# HISTORIC AND DESIGN REVIEW COMMISSION

October 02, 2024

**HDRC CASE NO:** 2024-254  
**ADDRESS:** 110 LEXINGTON AVE  
**LEGAL DESCRIPTION:** NCB: 804 BLK: 32 LOT: A5, A8  
**ZONING:** FBZ T6-2, H, RIO-2  
**CITY COUNCIL DIST.:** 1  
**APPLICANT:** Ellis Mumford-Russell/Post Oak Preservation Solutions LLC, Megan Moshier/Studio8 Architects  
**OWNER:** Ryan Bean/TRESTLE-TLC EL TROPICANO LP  
**TYPE OF WORK:** Construction of a cantilevered deck over the publicly owned right of way, construction of a staircase within the public right of way, landscaping  
**APPLICATION RECEIVED:** July 03, 2024  
**60-DAY REVIEW:** September 01, 2024 (postponed to October 2 by applicant)  
**CASE MANAGER:** Edward Hall  
**REQUEST:**

The applicant is requesting a Certificate of Appropriateness for approval to:

3 SECTION: CONCRETE STAIRS AT LIMESTONE WALL  
SCALE: 3/4"= 1'-0"

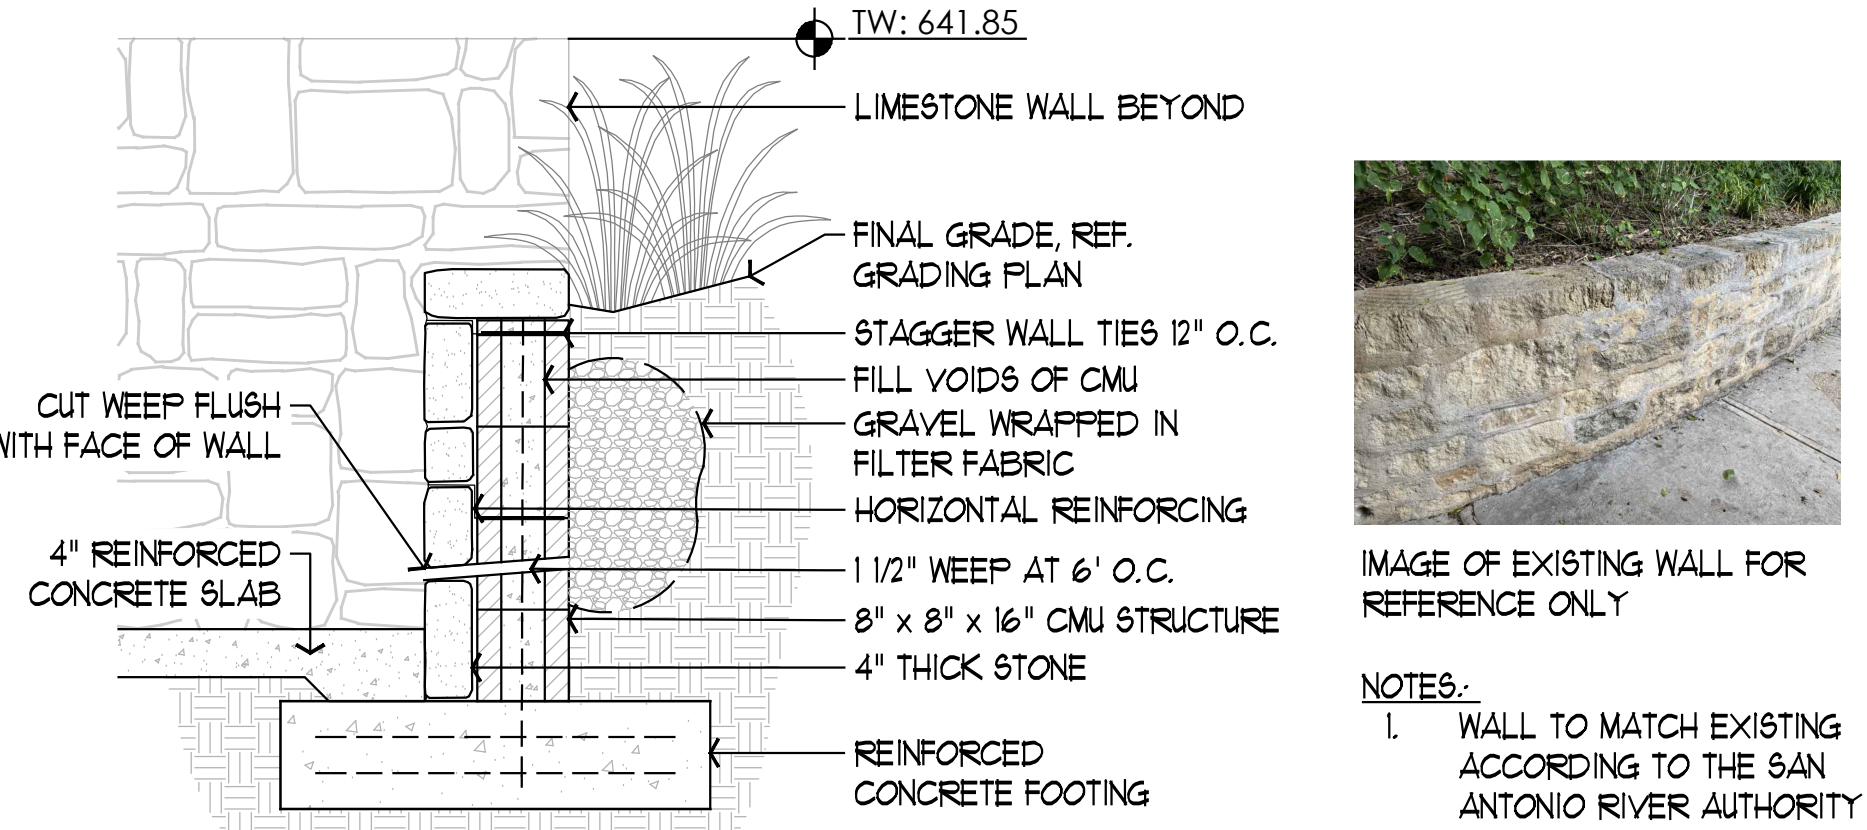
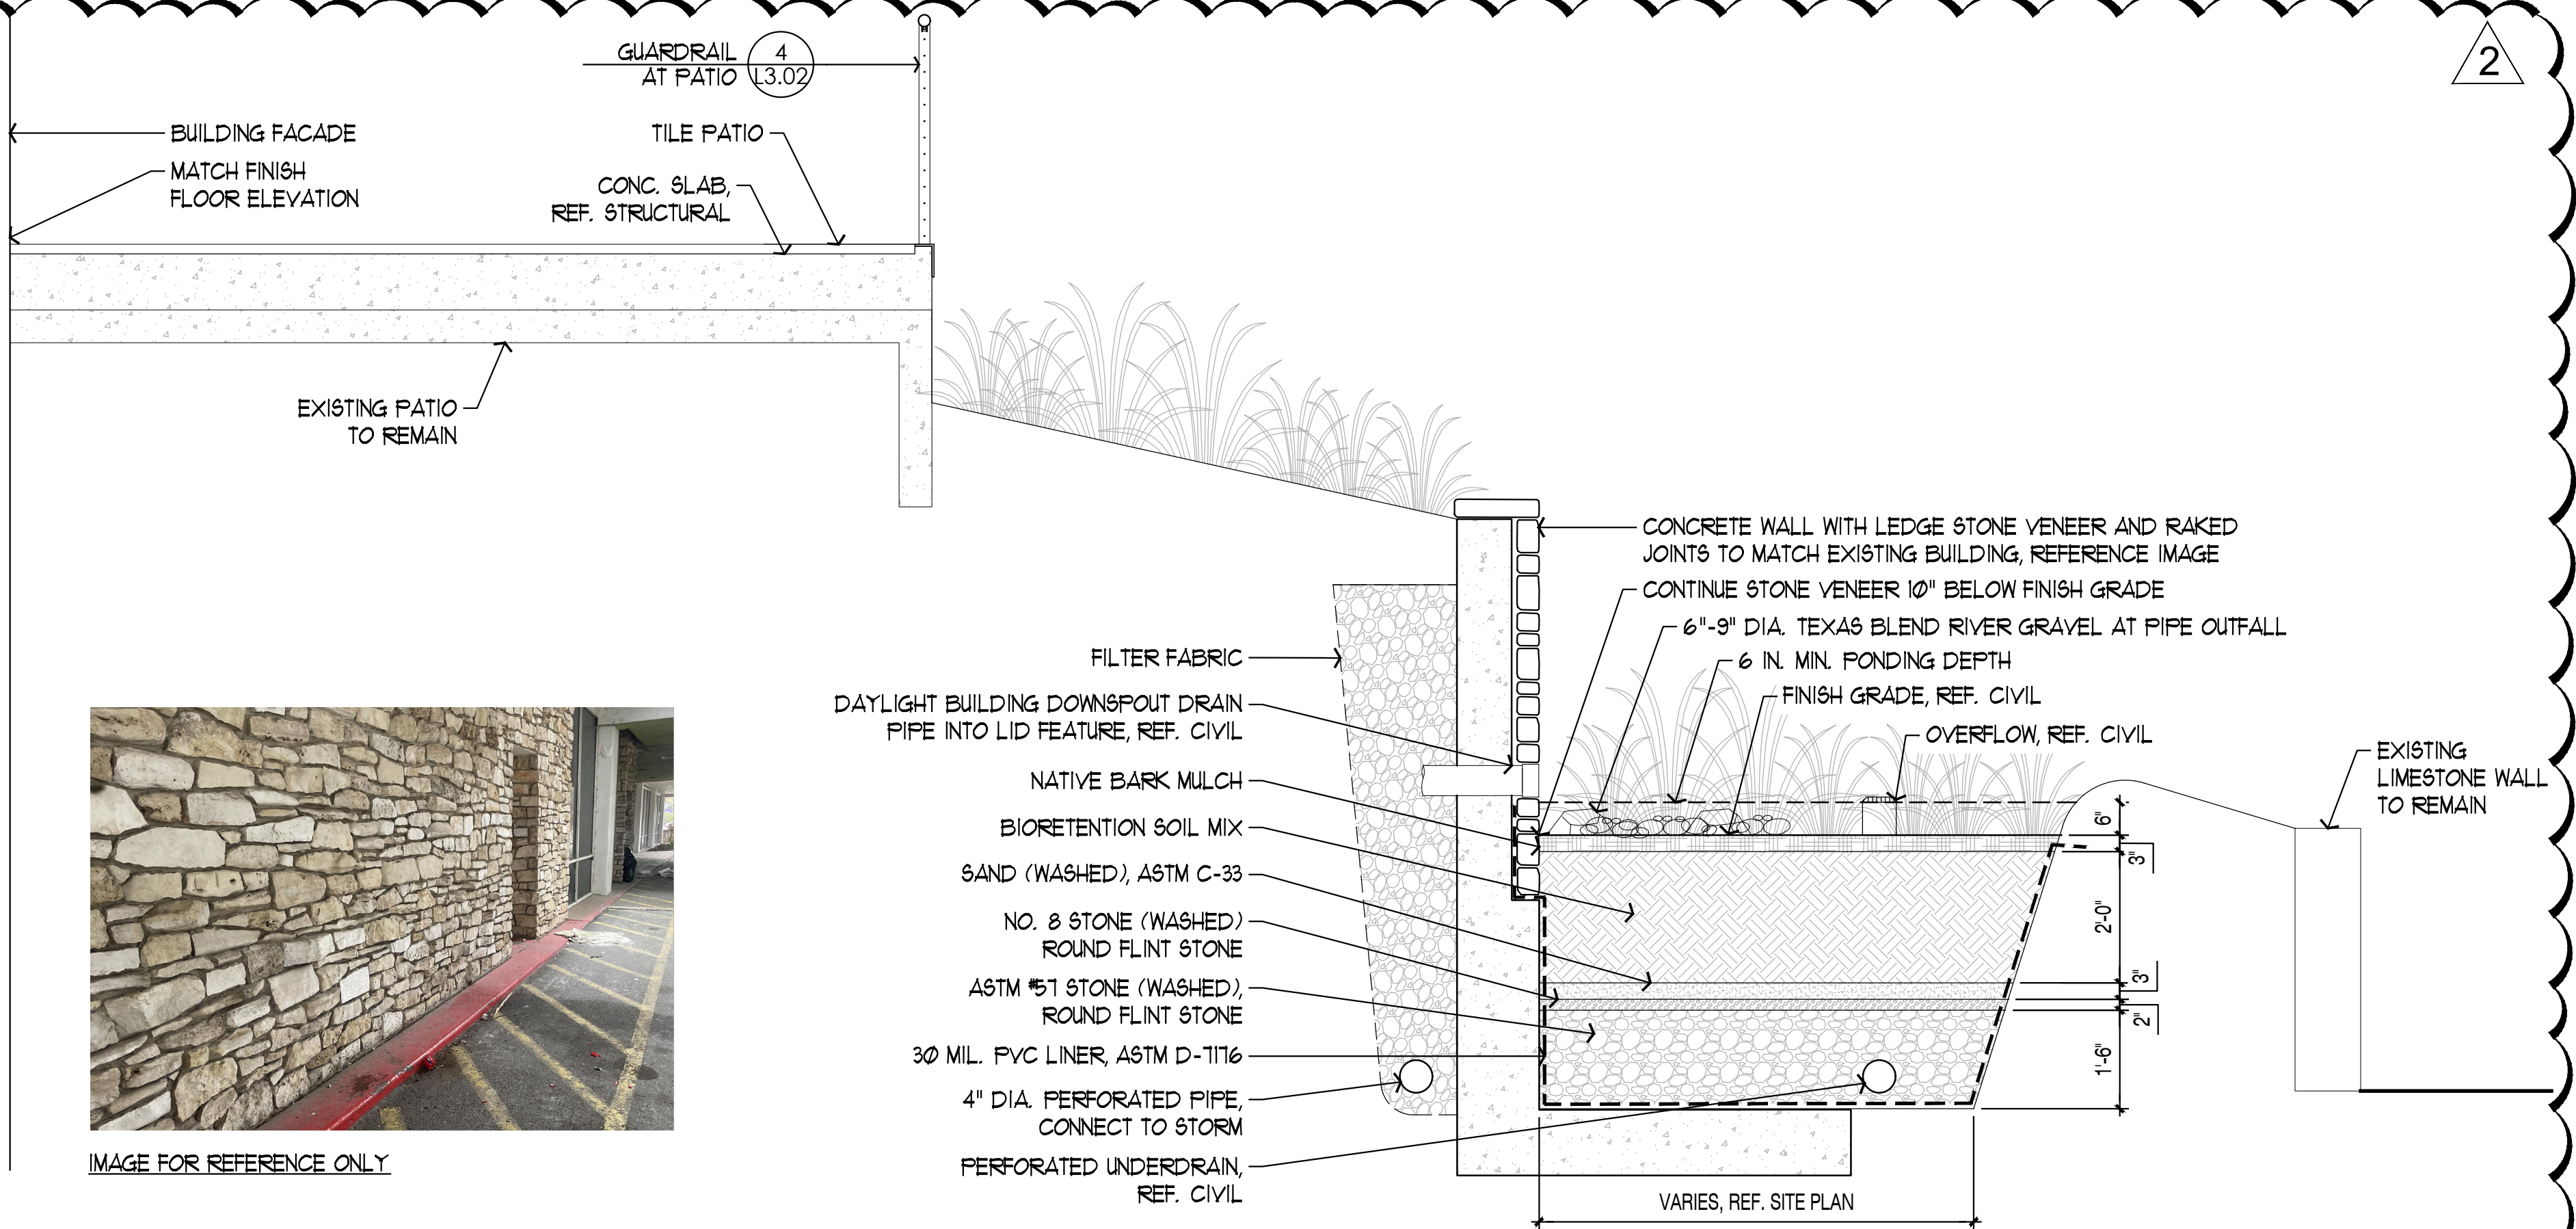
- d. STAIR CONNECTION – The applicant has proposed to construct a new staircase to connect the River Walk path with Lexington Avenue. The stair connection is to feature a curved profile and be constructed within the public right of way. The proposed connection is permitted per the UDC Section 35-673(o). The proposed stair will feature painted steel risers, painted steel formed cable guardrails, acid etched concrete risers and landscaping, and painted steel pipe handrails. The existing stone wall at river level will not be impacted by the proposed stair. Staff finds the proposed stair and its materials to be appropriate. Staff finds that the acid-etched

concrete landing should feature an overall finish and texture that relates to those found historically at the River Walk level.

# EL TROPICANO RIVERWALK DECK SECTION

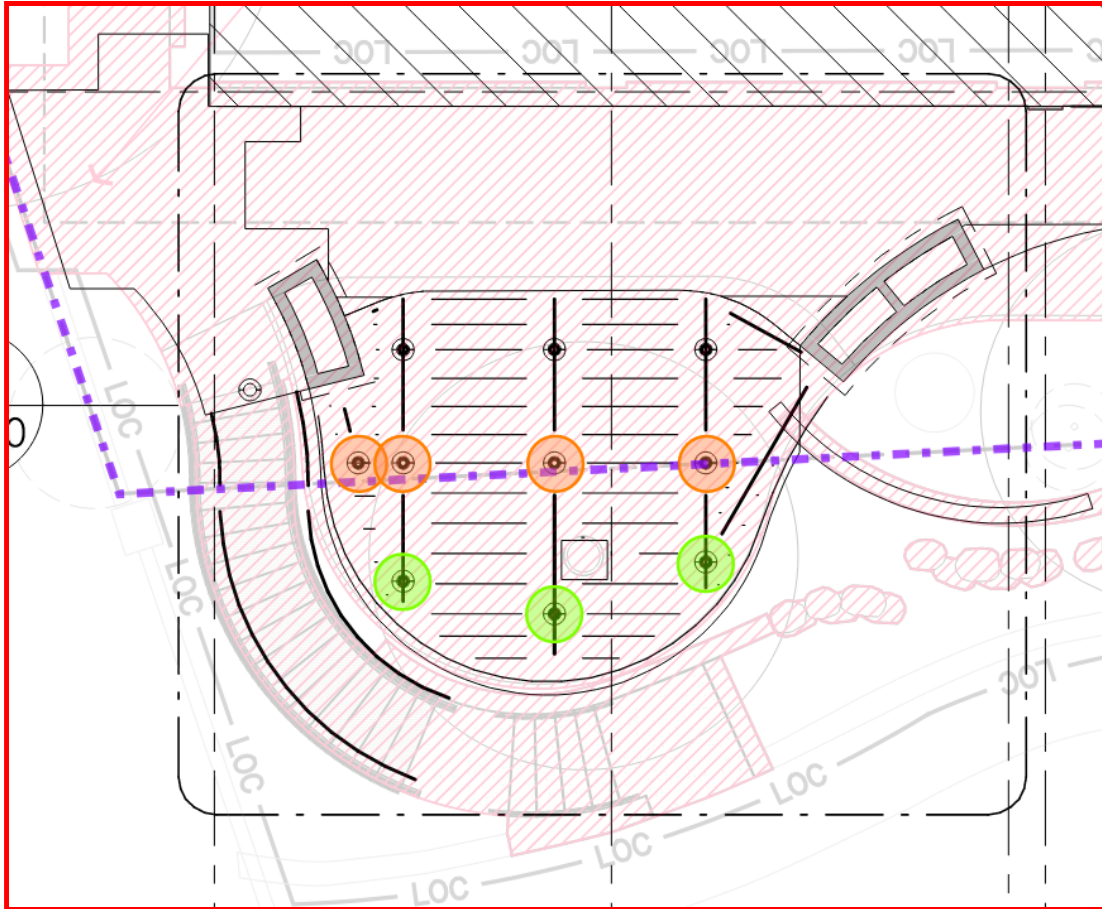
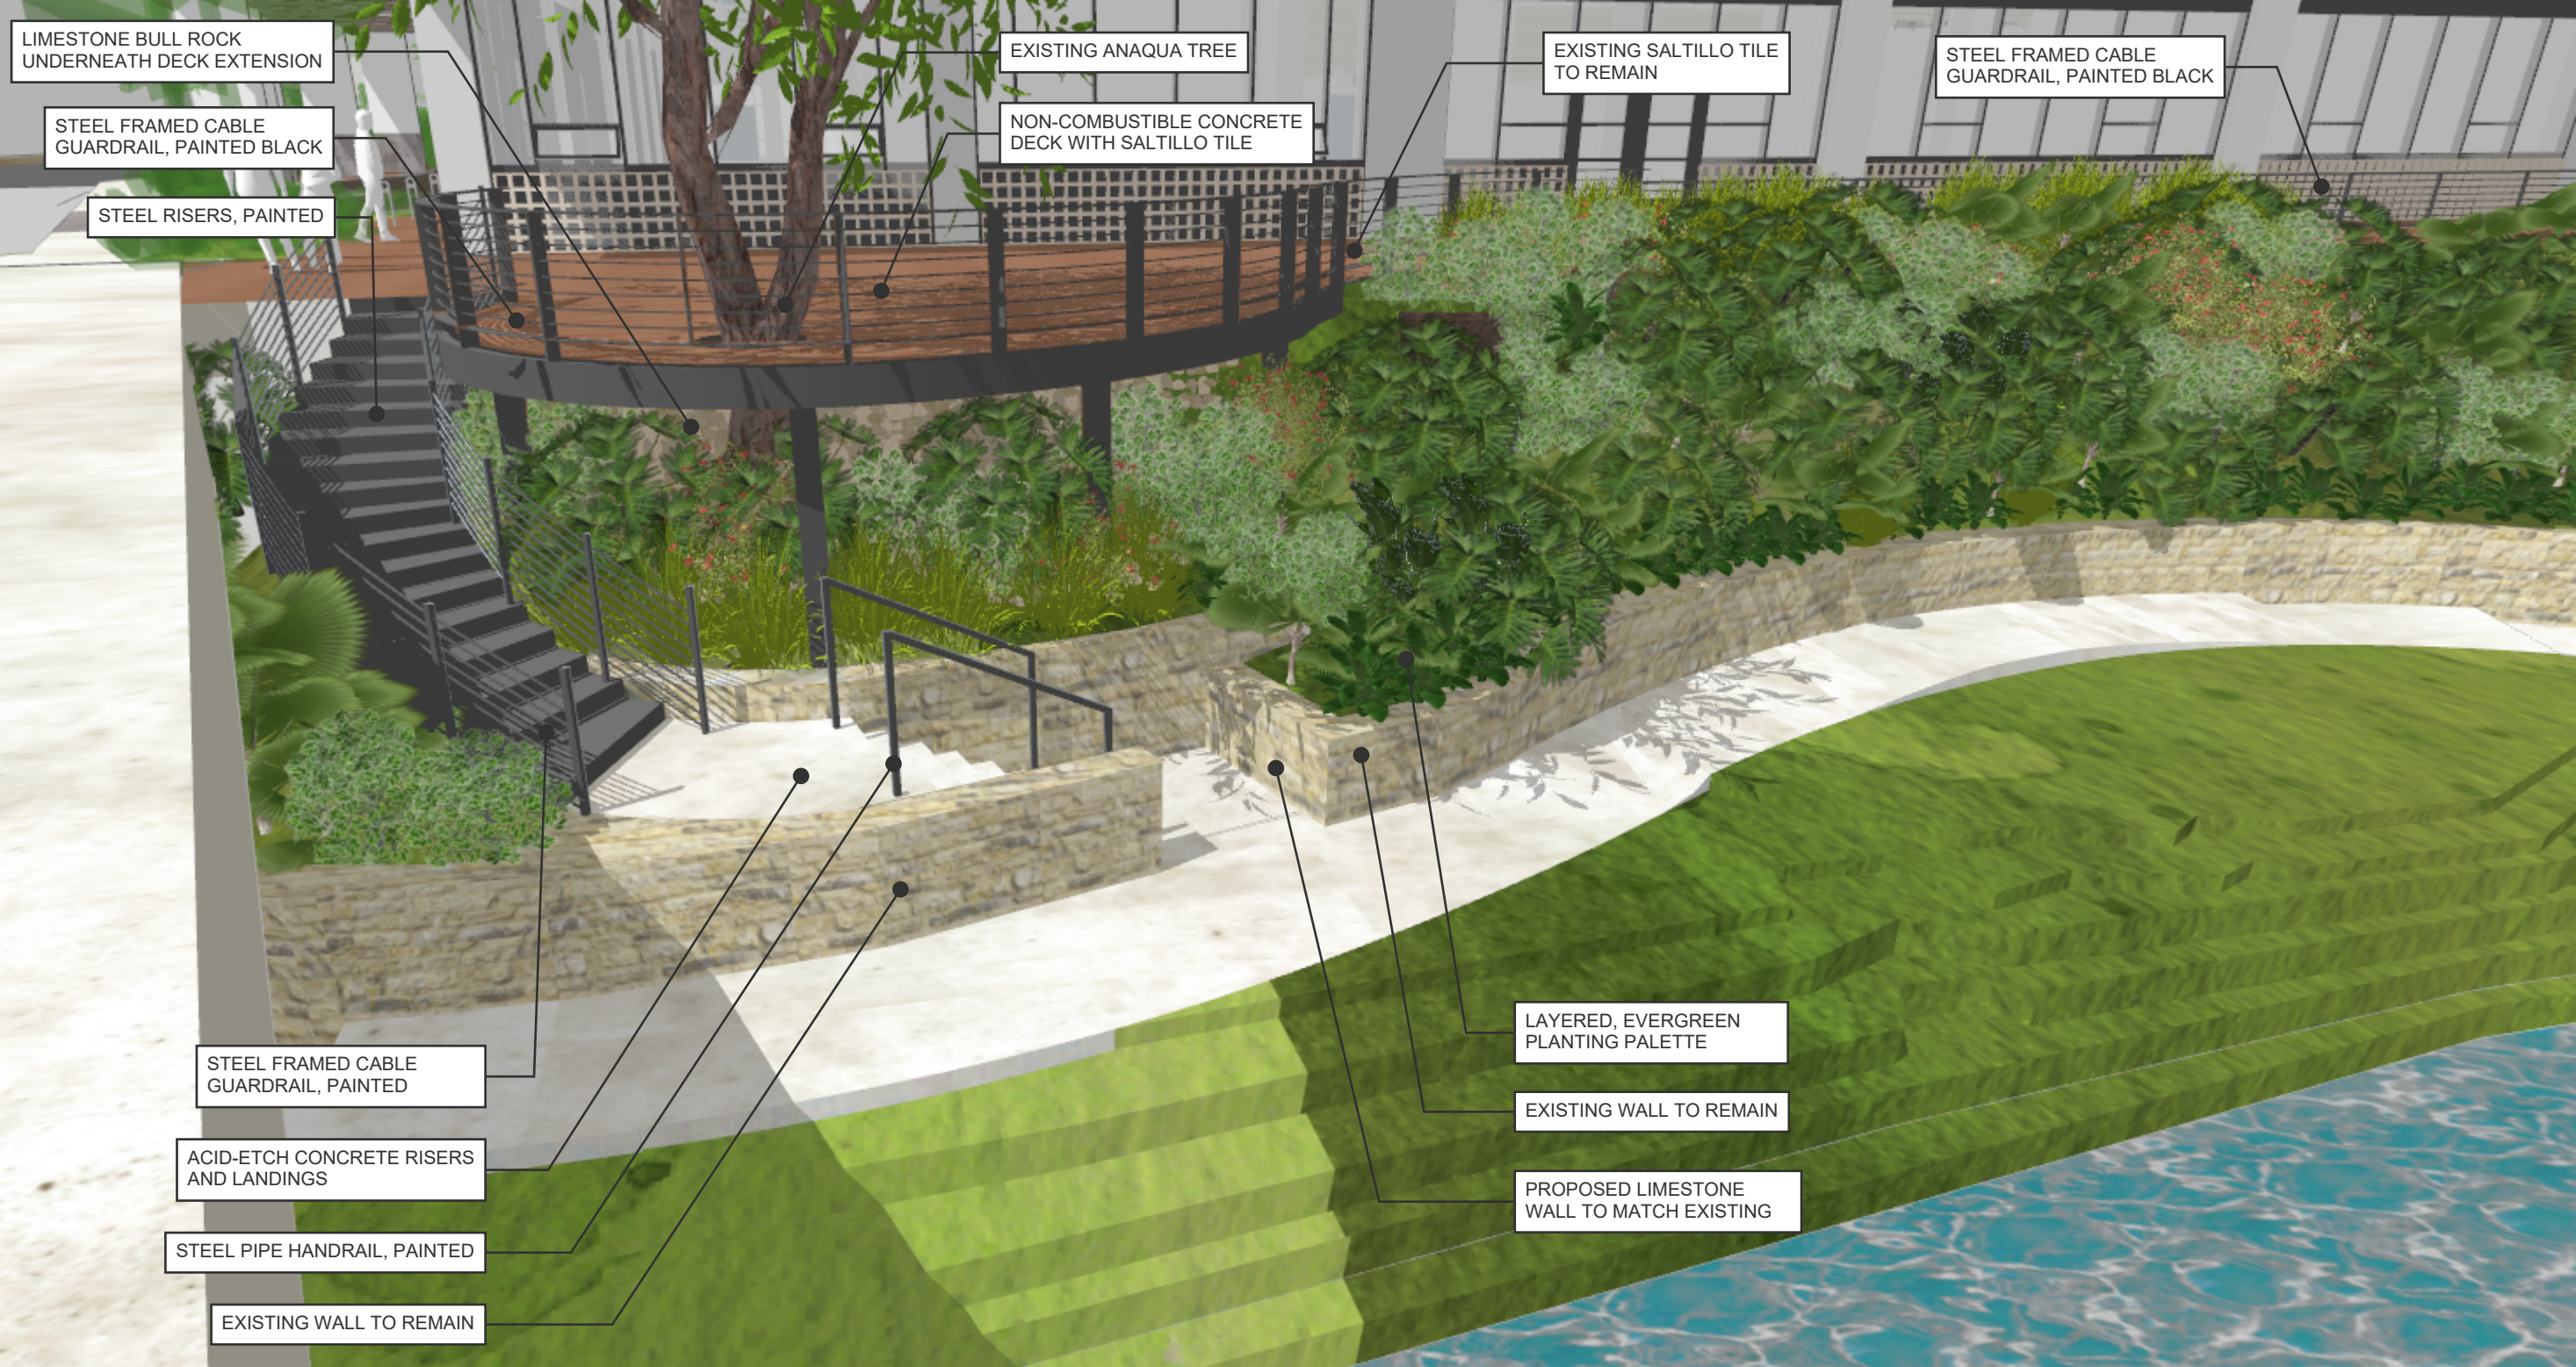
- e. CANTILEVER – The applicant has proposed to construct a cantilevered patio that will extend beyond the property line into City right of way at the location of the proposed stair. The patio will cantilever by approximately twelve (12) feet at its furthest point and will be approximately 8’ – 9” above a landscaped bed in the River Walk area. The UDC prohibits the encroachment of structures over the river channel which is defined as “natural course of the river as modified for flood control purposes.” This portion of the river channel contains a contemporary path with stone retaining wall. Staff finds that, in the spirit of the River Walk itself, there may be opportunities for overlooks, balconies, terraces, and other minor encroachments that are in keeping with the character of the River Walk. Staff also finds that in order to conform to the UDC, no overhead structure may encroach beyond the footprint of the original Hugman design or alter any known Hugman elements. The proposed patio is complementary to the site design, but will have some impact to landscaped areas. The patio requires support from structural columns. A total of seven (7) columns will impact public property, three of which will be on public property in their entirety. While these columns will be an impact to public property, staff finds their installation to be appropriate provided that the four columns that are partially on public property be shifted to the north to be removed from public property. All columns should be painted and detailed to match the steel members of the proposed deck and footings should be hidden by landscaping elements.

**INDICATES PILE BEYOND PROPERTY LINE (3 TOTAL)**

**INDICATES PILE AT OR NEAR PROPERTY LINE. THESE PILES CAN LIKELY BE COORDINATED TO SHIFT SLIGHTLY PLAN-NORTH TO AVOID CROSSING PROPERTY LINE BOUNDARY (4 TOTAL)**

- i. That the four columns that are partially on public property be shifted to the north to be removed from public property.
- ii. That all columns be detailed to match the proposed deck’s steel members and that the deck feature a deck surface that allows for drainage to the existing tree.
